INDESIT company

Model type:
MTA241

Commercial code:
F028990

Notices

0521123: SEALS FOR DOORS FOAMED AS ONE PIECE

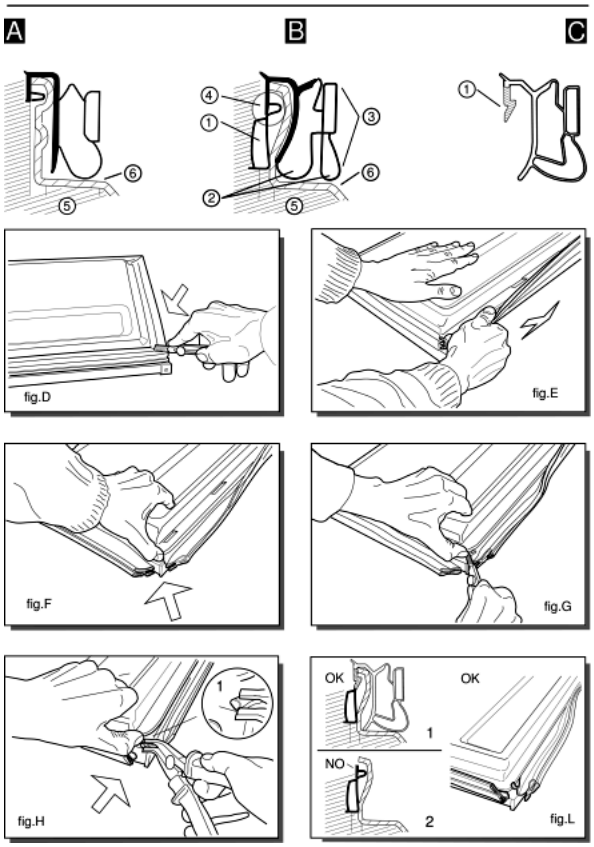
Various types of gaskets with different profile, as shown in figures (A) and (B), are used to fix the door (fig. A-5; B-5) and the inner door (fig. A-6; B-6) on the block foamed doors of combined freezers and refrigerators.
---Ilpea profile 245; 179; 412 (fig.A)
---Ilpea profile 287 (fig.B)
When replacing gaskets with profiles 245; 179; 412 these are fixed with screws (2 per corner) to the door.
Gaskets with profile 287 can not be used as spare parts but are designed to house the Ilpea type 900 gaskets (see figure C).
When replacing the gasket (287), once it is removed you will find a pocket (fig. B-1) between the door and inner door.
The rigid tooth (fig.C-1) of the gasket (900) is inserted inside between the pocket and the inner door, doing away with the need for screws.
Gasket with profile 287 is easy to identify since it has an exterior double edge (fig.B-2) which acts as a cushion when the door is closed.

To replace this gasket, follow these steps:
---Dismount the door and cut the four corners of the gasket along the joint (fig.D);
---lift the gasket and pull it carefully along its full length without tearing it (fig.E).
The purpose here is to detach the inner door slightly from the foam along the exterior edge for a depth equal to that of the gasket (fig.B-3);
---lift the corner of the inner door slightly, prising it up with your thumb (fig.F). Do not use a tool which might break the inner door;
---continue cutting the gasket inside the inner door for about 6 mm (fig.G);
---push in the tip of the pliers (type USAG N131) and pull outwards until you see the top edge of the pocket (fig. B-4) which is empty (fig.H-1);
---if you carry out this operation correctly (fig.L) you will be able to pull off the top edge of the pocket for the full length of the door.
If the gasket tears before the top edge (fig. L-2) you should repeat this operation from the other corner of the door.

---once the gasket (287), has been removed the space above the pocket (fig. L-1) can house the rigid tooth (fig. C-1) of the gasket 900.
When you fit this gasket ensure that it lies flush against the edge for the full length of the door.
If the rigid tooth is difficult to fit, eliminate any residues of foam between the door and the inner door in the gasket area.
fig.5131549A

n1025158: New central hinge for Ariston-55 2-door 240 litre refrigerators (Carinaro).

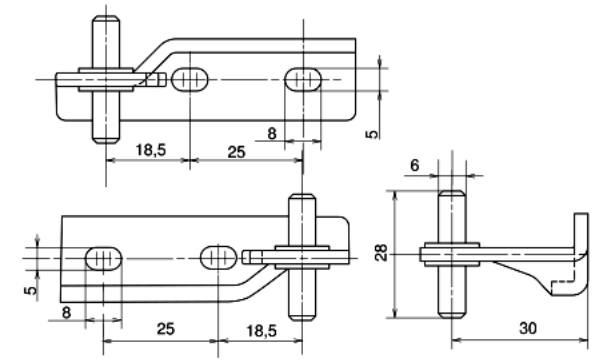
From serial no. 60123.0001, the Carinaro factory has modified the body of 240 litre refrigerators by introducing a new central hinge (see figure N1025058 Fig.1) attached to the side panel.
This hinge is still reversible but cannot be fitted on premodification models where the hinge was attached to the central trim of the refrigerator body (see Figure N1025058fig2).
When changing the door opening from right to left, the new hinge does not need to be inverted like the previous one, just moved to the left side.
To secure it, a hole must be made on the left side of the refrigerator body (see figure N1025058fig3).

OLD 053838 - 053478 - 114624

NEW 141794 - 142760 - 142756

141794 - POLAR WHITE CENTRAL HINGE (CARINARO)
142756 - POLAR WHITE CENTRAL HINGE (MANISA)
142756 - CHROME-PLATED CENTRAL HINGE

053838 - CHROME-PLATED CENTRAL HINGE
053478 - WHITE CENTRAL HINGE
114624 - POLAR WHITE CENTRAL HINGE

n1025158FIG2

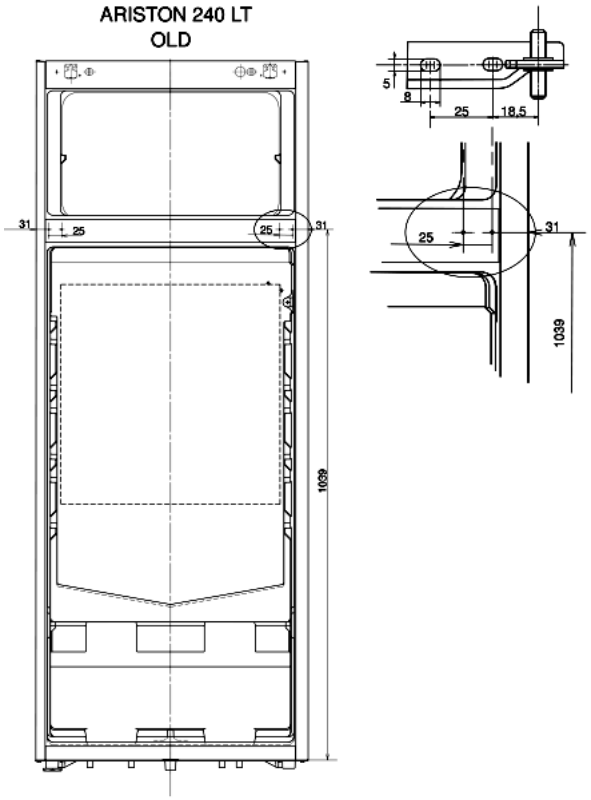
ARISTON 240 LT
OLD
